Service Instruction

Service Instruction Number: HF-S-2

Subject: Rerouting of auxiliary tank vent line if existing hydraulic service ports or existing equipment interfere with installation of vent line per Helifab drawing number HF-S76-I-7.

**Figure 1
Auxiliary Fuel Tank Assembly**

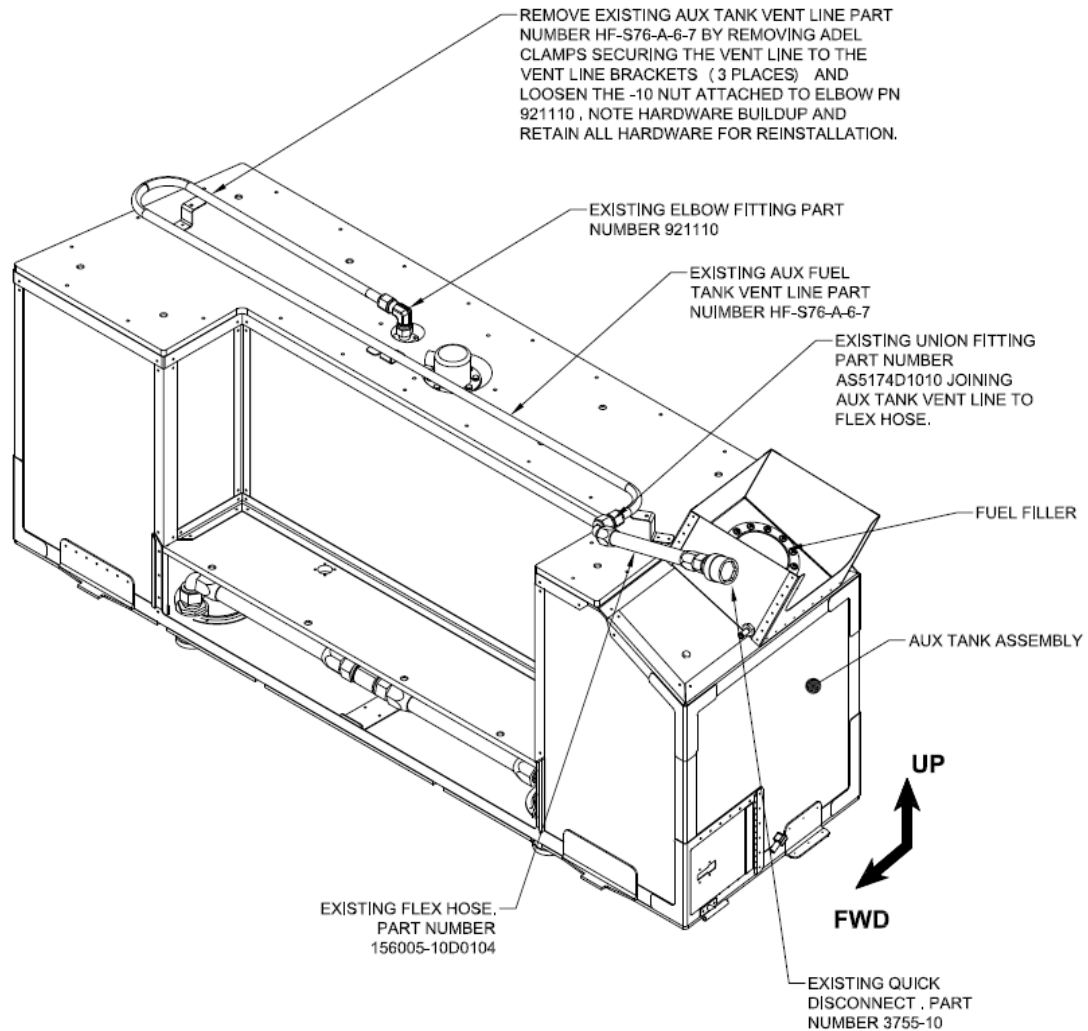
1. Remove existing auxiliary fuel tank vent line part number HF-S76-A-6-7 from the auxiliary fuel tank assembly by removing three existing adel clams and loosening the -10 nut attaching the vent line to elbow part number 921110 (see figure 1). Note existing hardware buildup and retain hardware for reinstallation.

Figure 2
Auxiliary Fuel Tank Vent Line Modification

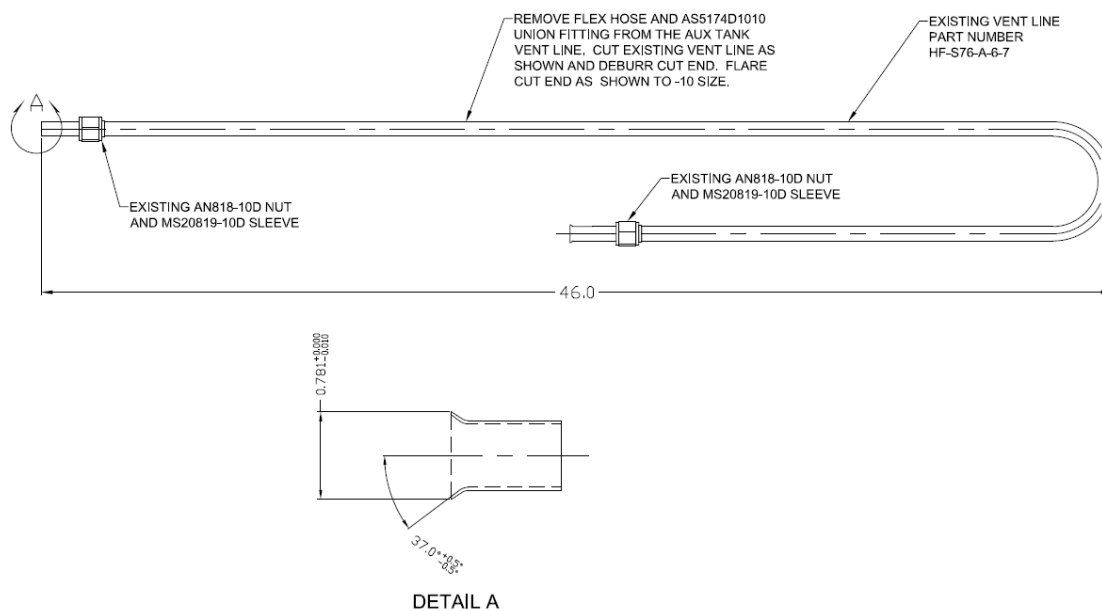
2. Remove the quick disconnect hose part number 156005-10D0104 and AS5174D1010 union from the aux tank vent line (see figure 2). Discard union PN AS5174D1010.
3. Cut vent line, deburr cut end of vent tube, and flare cut end of tube as detailed in figure 2.
4. Locate two new vent line brackets (PN HF-S76-D-6-26 and HF-S76-D-6-27) to the auxiliary fuel tank assembly and match drill $\varnothing 0.1285$ holes from the vent line brackets to auxiliary fuel tank panel PN HF-S76-D-2-75. Deburr all holes, maximum depth of hole deburr to be 10% of material thickness. (See figure 3)

Figure 3
Auxiliary Fuel Tank Vent Line Installation

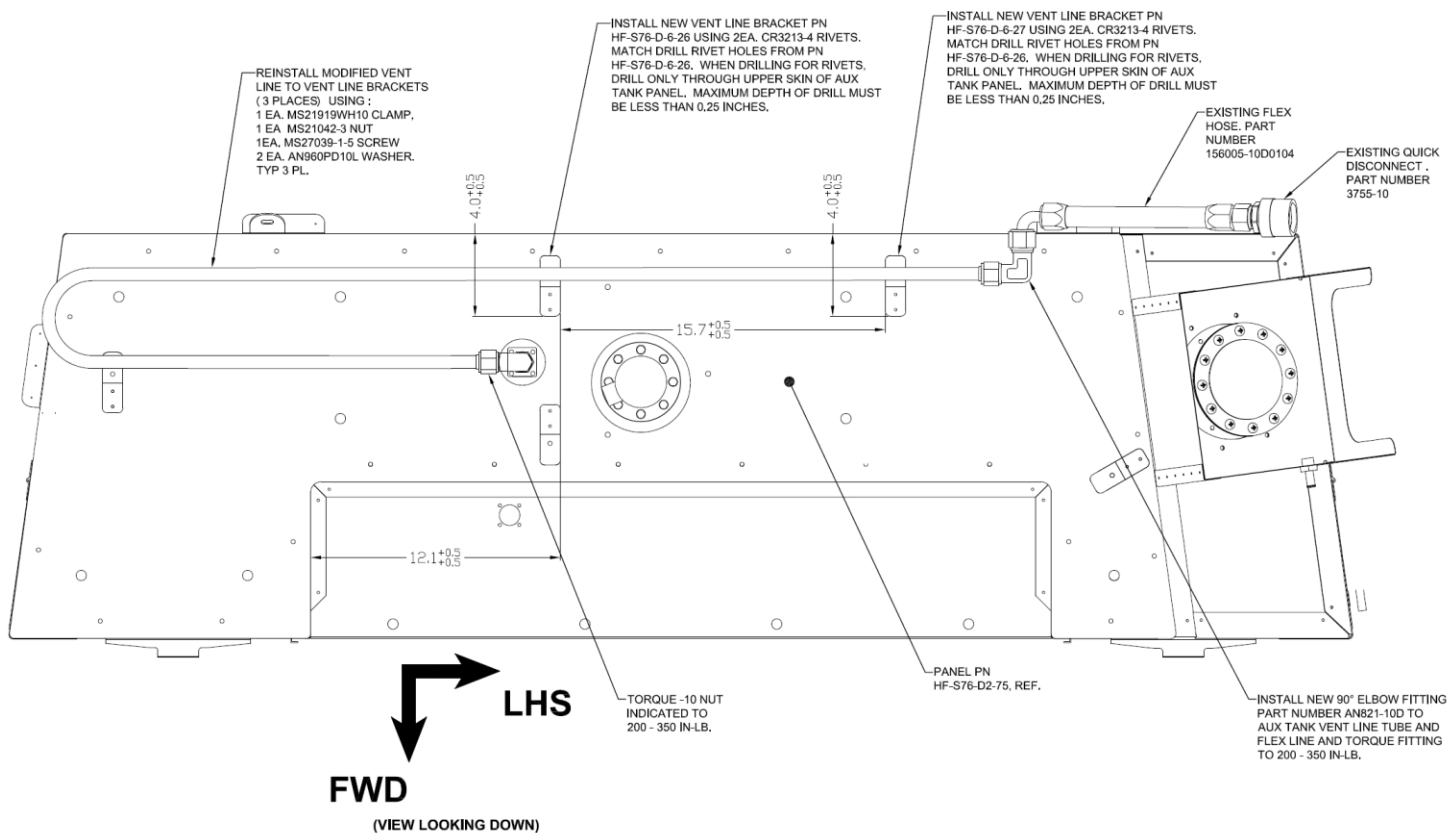
5. Install vent line brackets (PN HF-S76-D-6-26 and HF-S76-D-6-27) to the auxiliary fuel tank assembly using 2 each CR3214-4 rivets (See figure 3).
6. Ensure modified aux tank vent line is free of dirt and debris and install auxiliary fuel tank vent line to auxiliary fuel tank assembly using same hardware removed in step 1 (See figure 3).

7. Install new 90° elbow fitting (PN AN821-10D) to the end of auxiliary fuel tank vent line (See figure 3).
8. Install flex hose removed in step 2 to 90° elbow fitting (PN AN821-10D) (See figure 3).

9. Torque all -10 size flare nuts to 200-350 in-lb (See figure 3).
10. Cut existing left hand (LH) fuel tank vent line as detailed in figure 4 and 5. Deburr cut ends of existing vent line.

Figure 4
Auxiliary Fuel Tank Vent Manifold Installation

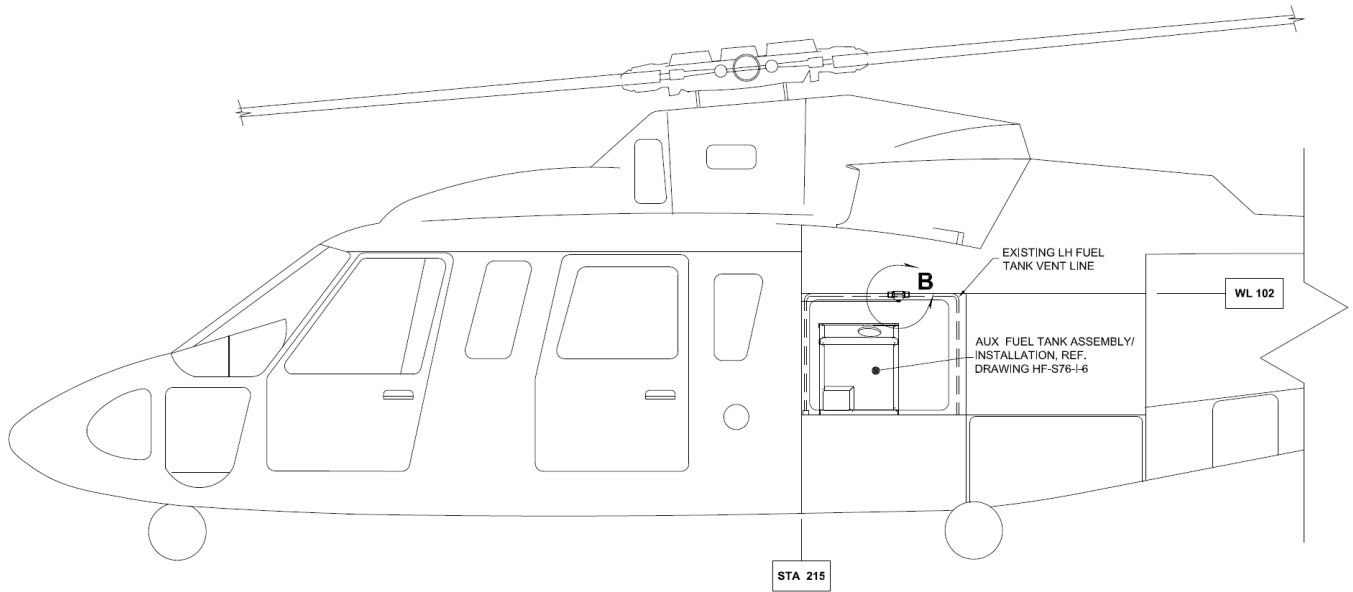
11. Install MS20819-12D sleeve and AN818-12D nut to each section of existing vent line and flare cut ends of vent line tube as detailed in figure 5.
12. Ensure existing LH fuel tank vent line is free of dirt and debris and install vent manifold assembly part number HF-S76-A-7-1 to the existing LH fuel tank vent line.
